## **UL 1449 Third Edition**

**- Published Oct 2, 2006, Effective Sept 28, 2009**

### **Major Revisions:**

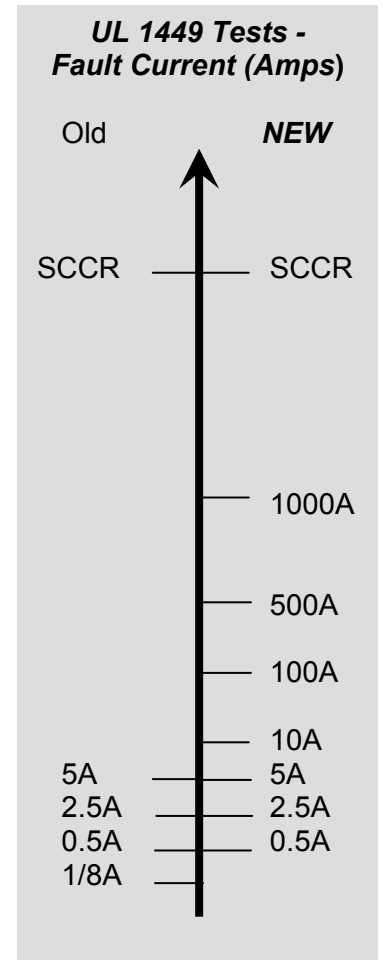
Change adds 10A, 100A, 500A and 1000A fault current withstand testing to previous tests of 0.5A, 2.5A, 5A and manufacturer-selected Short Circuit Current Rating (SCCR). Old & new current levels shown below; 1/8A test is now deleted. The purpose of this testing is to better simulate failure modes caused by sustained overvoltages at various currents. This change closes a former blind spot between 5A and SCCR. Does not apply to N-G mode on Type 1 or Type 2.
